INVERNESS
PLANNED OVERALL AREA DEVELOPMENT PLAN/ PLANNED UNIT DEVELOPMENT POADP/PUD

Re: Inverness POADP # 574

The City Staff Development Review Committee has reviewed Inverness Subdivision Preliminary Overall Area Development Plan # 574. Please find enclosed a signed copy for your files. Although your plan was accepted, please note the following:

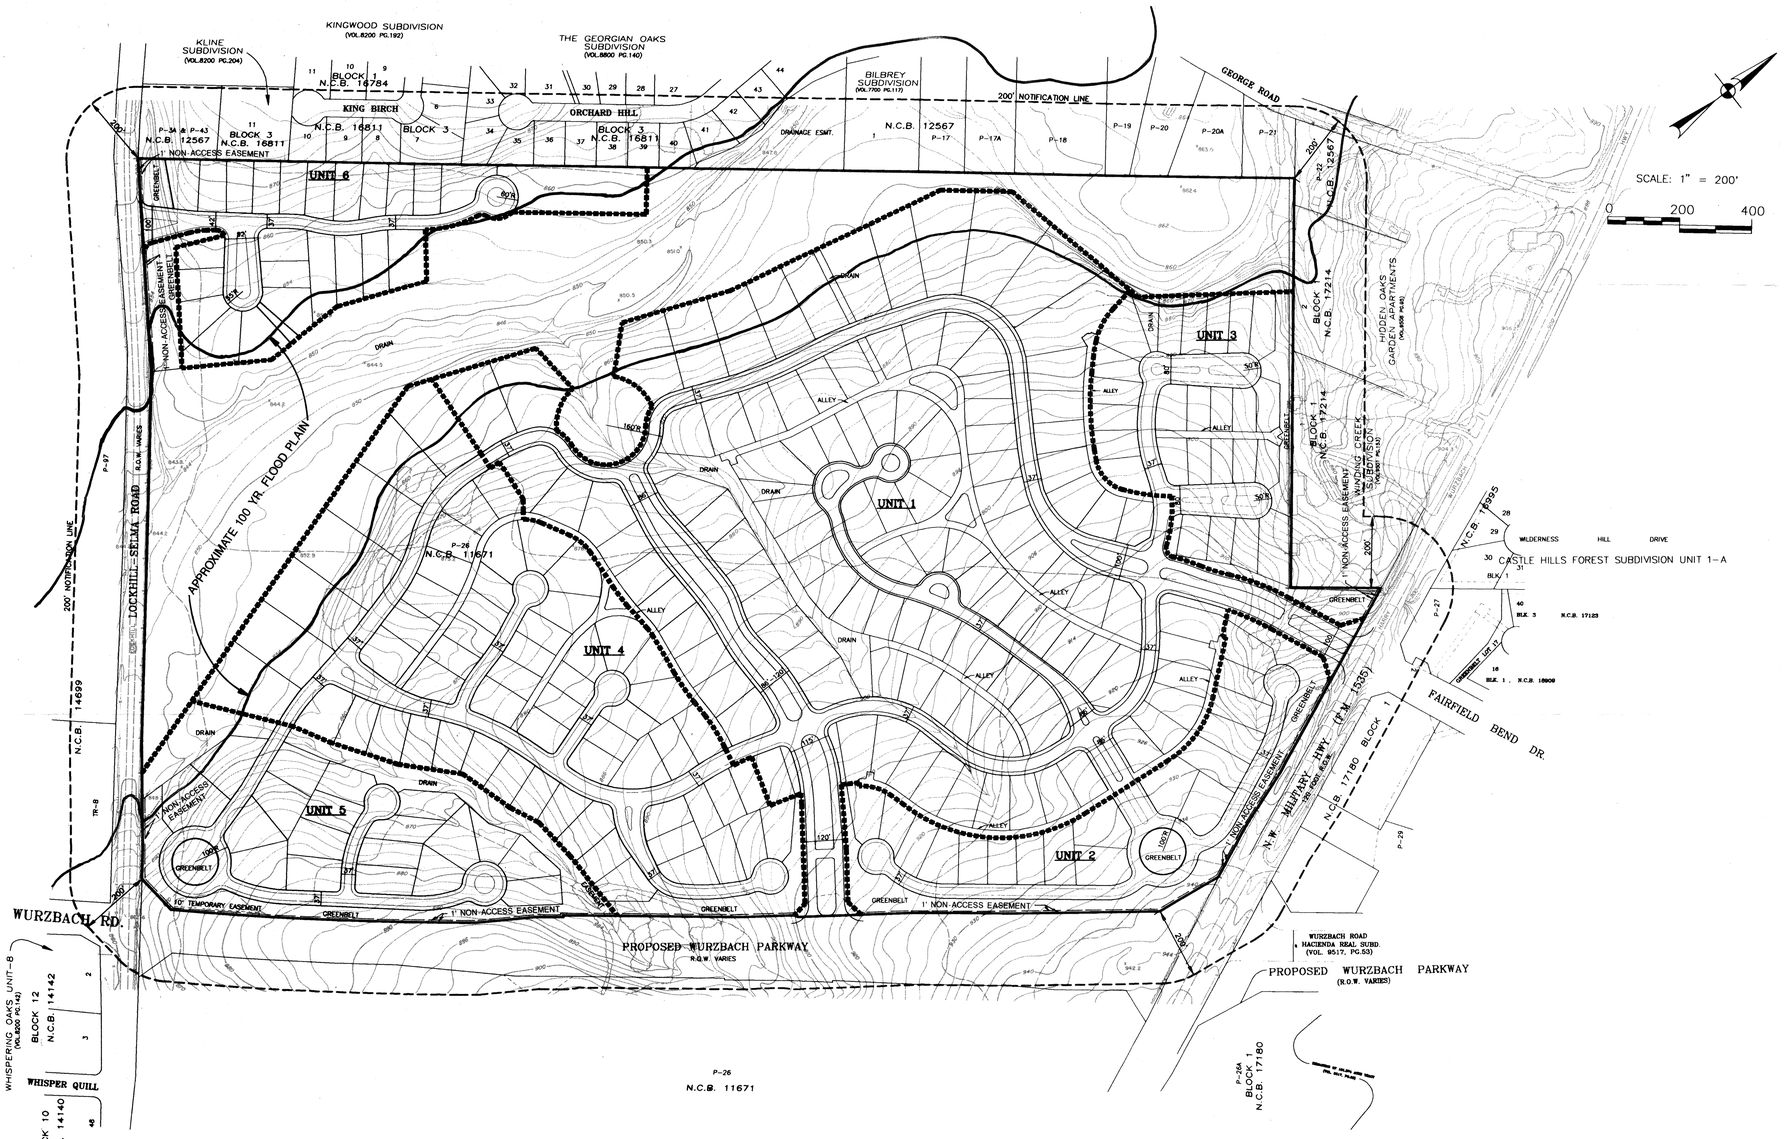
- Access and R.O.W. issues along State facilities will need to be resolved with the Texas Department of Transportation (TXDOT). For additional information about these requirements you can contact TXDOT at 615-5814.
- Based on the topography, a Flood Plain Study and drainage review will probably be required during the platting process.
- This development will need to comply with tree preservation ordinance #85262. For additional information about these requirements you can contact Building Inspections at 207-7102.

Comments: 1. T/A Reqd

2. Gate Details Reqd.

Some l/s might be causing Sight-Distance Problem

Comments: Flood Plain requirement and drainage easement will be ~~[illegible]~~ required and will be address during the platting process

Comments: Flood plain requirements and drainage easements will be required and address during the platting process.

Comments: POAD P Needs to reflect 120 feet of ROW along NW Military Hwy 86 feet of ROW along Lockhill-Selma Minimum 120 feet of ROW along Wurzbach Pwy

REVISIONS:
AUGUST 4, 1997
AUGUST 6, 1997: ADDED NON-ACCESS EASEMENT.

Attached please find six (6) prints of the above referenced plan, revised indicating the non-access easement adjacent to Lockhill-Selma Road, N.W. Military Hwy., and the proposed Wurzbach Parkway. Access for the lots will be from the private streets and/or alleys.
